SUBJ: Responses to Vendor's Questions

BID ITEM: Bid Item #22-193 Augusta Canal-Bulkhead Gate Repair - for Augusta, GA –
Utilities Department

ADDENDUM NO. 3

Augusta Canal Bulkhead Gate Repairs

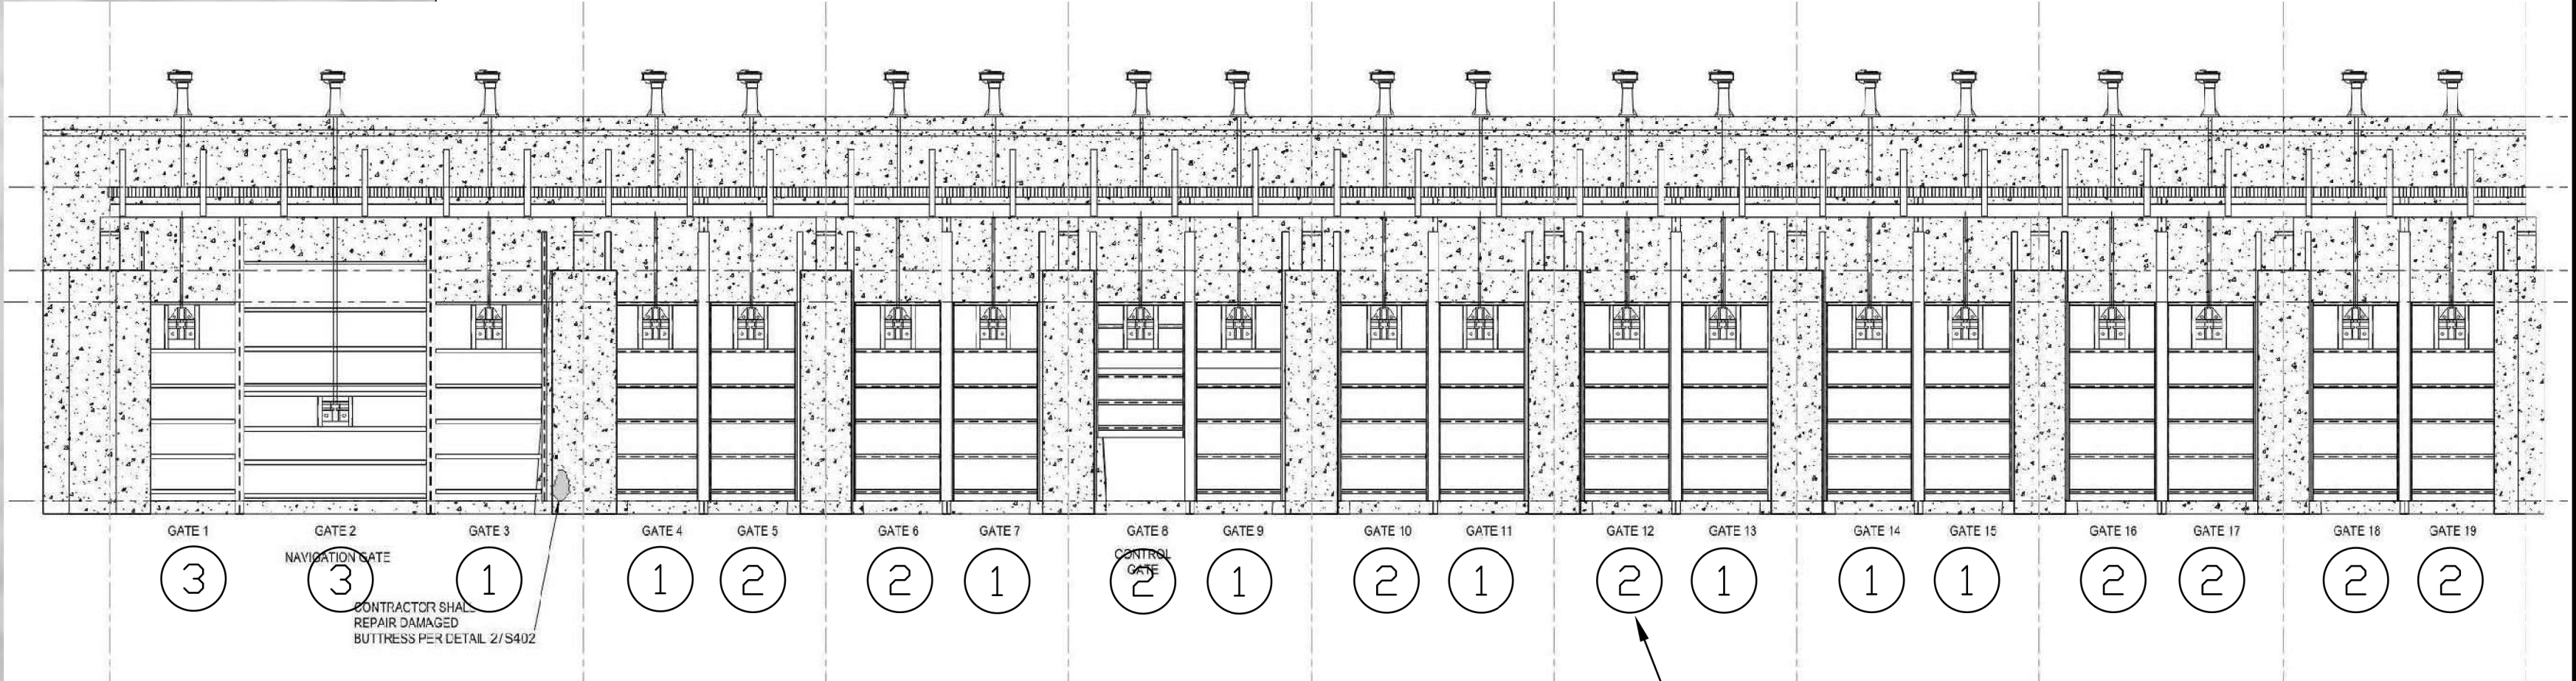
APPROXIMATE AREA OF FLOATING AND SUBMERGED DEBRIS
APPROX AREA: 7,200 SQFT
APPROX VOLUME: 800 CYD
ASSUMPTION: OBSERVED AREA INCLUDES A DEBRIS DEPTH OF 3-FEET
